INVITATION FOR BID # 16PB020

SHEA TUNNEL ACCESS SHARED USE PATHWAY

ADDENDUM #1

MAY 2, 2016

Log of Test Pit Number: **TP-1**

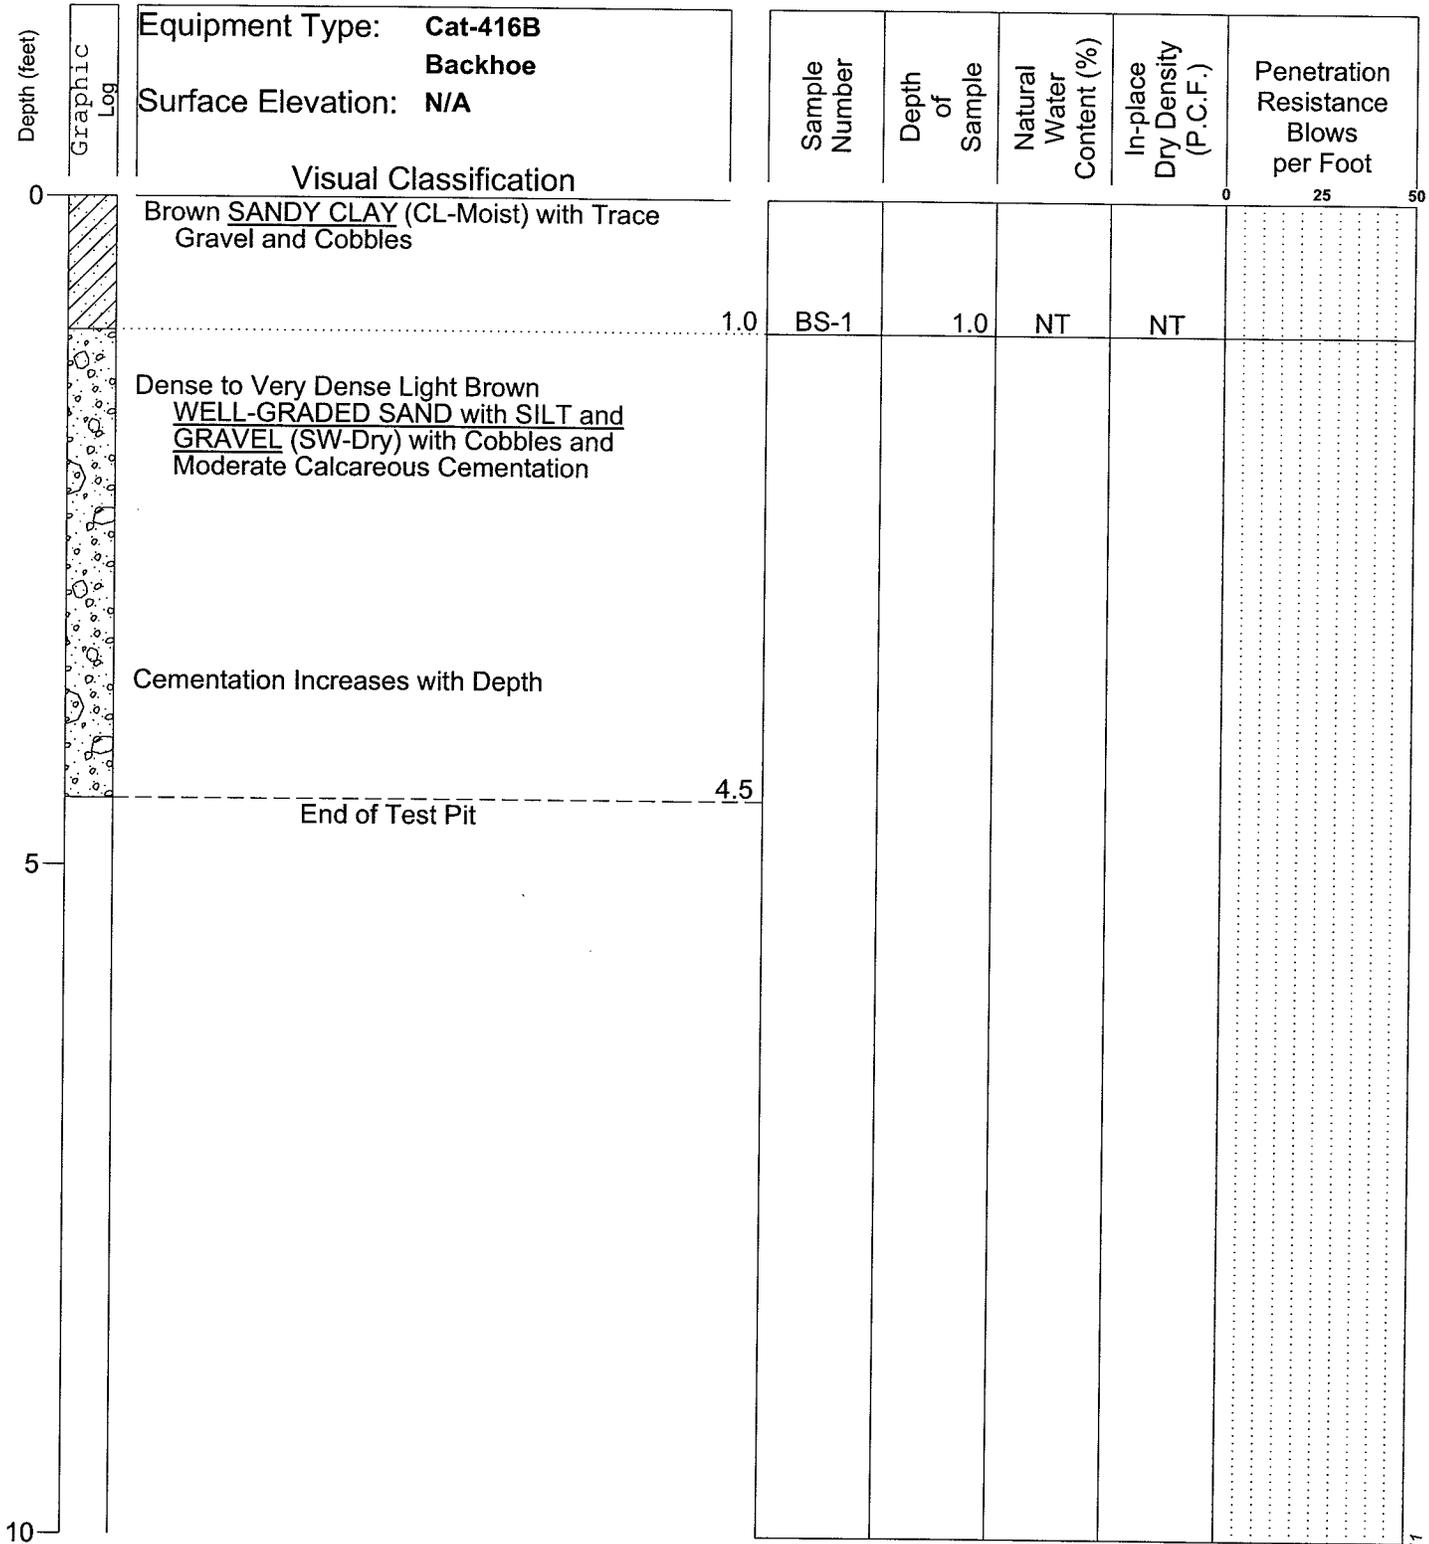
3. The test pit TP-1, as shown in the attached geotechnical investigation by Speedie and Associates dated January 20, 2011, is 8.5 feet deep and shows that cementitious density increases with depth. Excavation limits shown on the plans for the proposed wall are based on the cementitious material being present for the entire depth of the excavation. During excavation, if soil conditions differ from materials encountered at the bottom of TP-1, the contractor shall stop excavation work and notify the engineer.
